Item Name: Bubble Window, RH

DESIGN <i>GP</i>	DRAWN BY <i>LE</i>	DART AEROSPACE LTD HAWKESBURY, ONTARIO, CANADA	
CHECKED <i>IP</i>	APPROVED <i>H</i>	DRAWING NO. DSI 9329	REV. B SHEET 1 OF 1
DATE 06.06.26		TITLE BUBBLE WINDOW INSTALL MOD.	SCALE NTS
A	06.04.25	NEW ISSUE	
B	06.06.26	CHG TO EFFECTIVE AFTER CHG 002

## DART SERVICE INSTRUCTION

TO AMEND INSTALLATION INSTRUCTIONS IIN-D044-713 REV. A

**FIGURE 1**

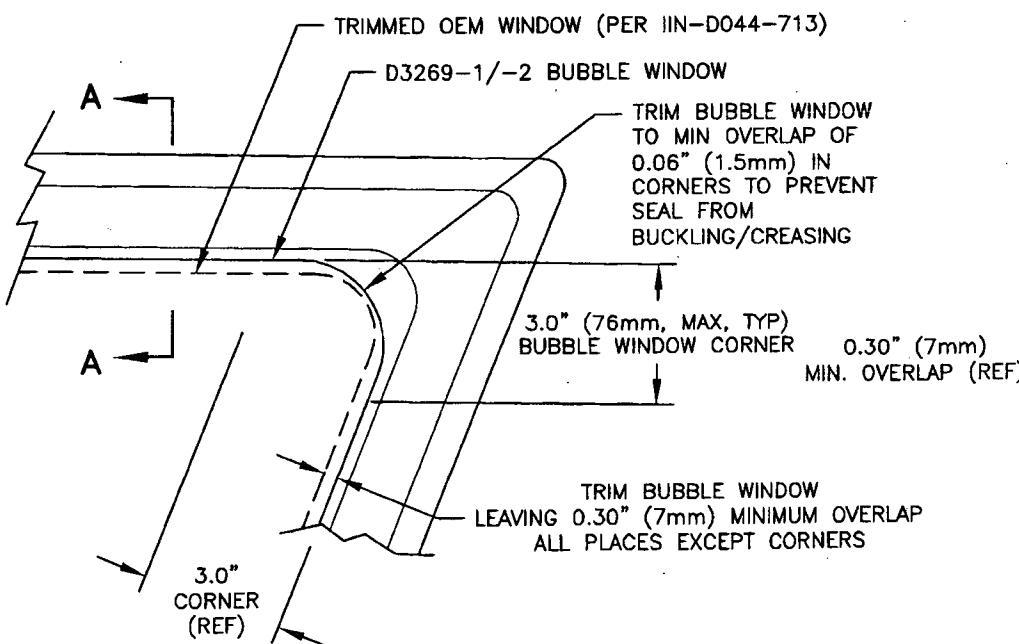
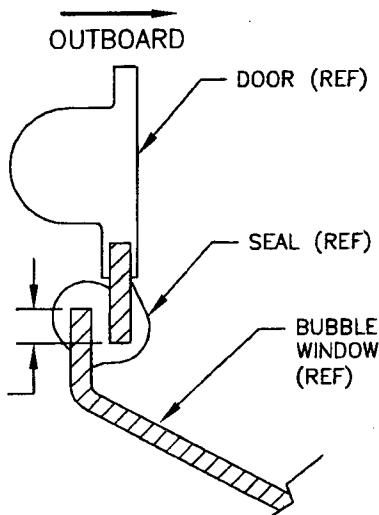
**PURPOSE:** For the D044-713-013/-014 kits supplied after CHG 002, the D3267-1/-2 bubble windows have been supplied untrimmed to allow for easier installation in the field. The installer must trim the windows in accordance with these instructions prior to installation.

- 1) Modify the R44 crew door per items 3.2.1 and 3.2.2 of Installation Instructions IIN-D044-713 Rev.A.
- 2) Fit and trim the D3269-1/-2 Bubble Window to match the cutout in the door as follows: The bubble window must be a minimum of 0.30" (7mm) larger than the cutout in the OEM window as shown in the figure below. However, in the corners of the window, it is acceptable to trim a 0.06" minimum overlap (1.5mm) to help prevent the D2126-0903 Seal from buckling/creasing in the corners. The edge of the bubble window must be deburred to a smooth finish.
- 3) Continue installing the bubble window per items 3.2.3 through 3.2.5 of the installation instructions.
